**MONTGOMERY COUNTY HISTORIC PRESERVATION COMMISSION**  
**STAFF REPORT**

<b>Address:</b>	15 E. Lenox St., Chevy Chase	<b>Meeting Date:</b>	6/28/2017
<b>Resource:</b>	<b>Contributing Resource</b> Chevy Chase Village Historic District	<b>Report Date:</b>	6/21/2017
<b>Applicant:</b>	Thomas Lloyd (Phillip Long, Agent)	<b>Public Notice:</b>	6/14/2017
<b>Review:</b>	HAWP	<b>Tax Credit:</b>	No
<b>Case Number:</b>	35/13-17N	<b>Staff:</b>	Michael Kyne
<b>PROPOSAL:</b>	Fence replacement and driveway replacement

1. EXPOSED AGGREGATE DETAIL  
SCALE: 1/8" = 1'-0"

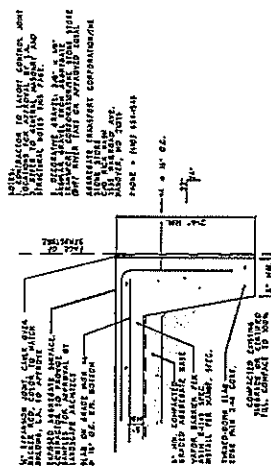
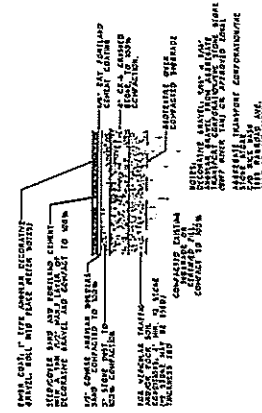
The proposed gravel driveway will have a fieldstone border, which is compatible with the property and historic district. A flared concrete apron will be installed at each end of the half-circle driveway, and where each end of the driveway intersects the public sidewalk, brick will be installed to match the sidewalk.

An existing gravel ribbon driveway at the left side of property will be replaced with an exposed aggregate ribbon driveway in the same approximate footprint. A 15' wide exposed aggregate turnaround will be installed at the end of the ribbon driveway at the rear/left side of the property in front of a previously approved garage (December 2, 2015 HPC meeting).

*Proposed Iron Fence Details*

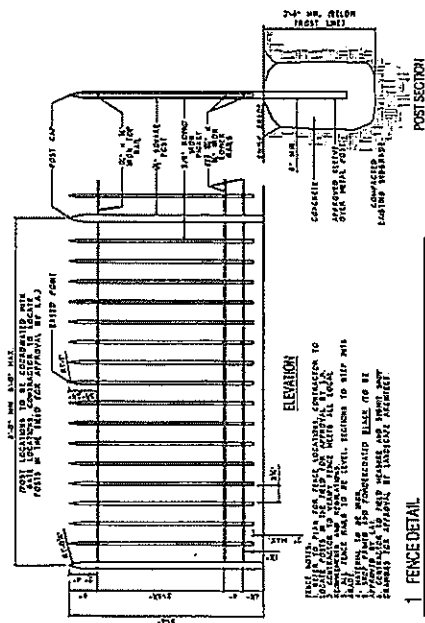
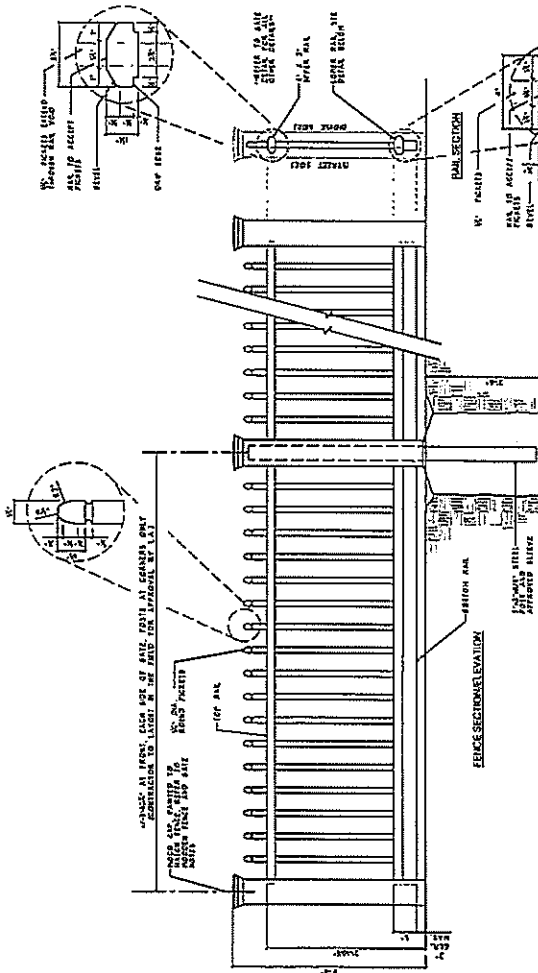
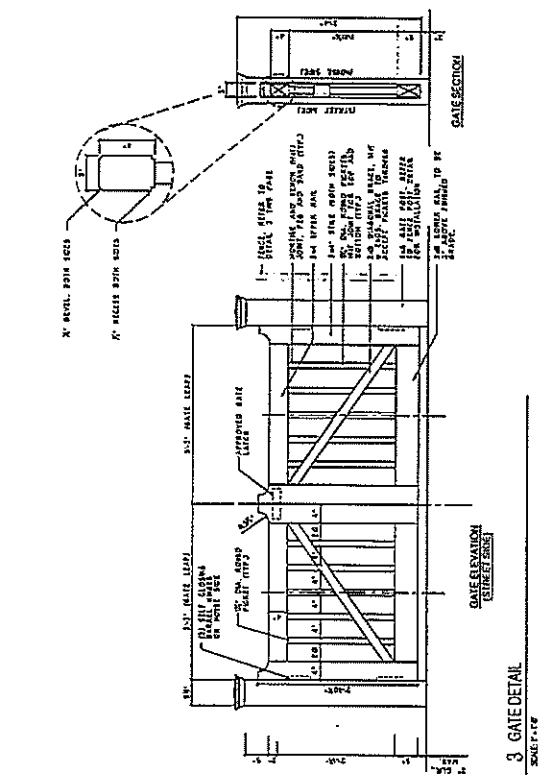
A 3'-6" solid iron picket fence is proposed along the right property line, beginning approximately 23' from the front property line. An 8' wide section of solid iron picket fence will be installed parallel to the front property line, intersecting with the proposed wooden picket fence. The proposed solid iron fence will have top and bottom rails, which will be welded to the pickets. The proposed fence preserves the open park-like character of the historic district and is generally compatible with the subject property.
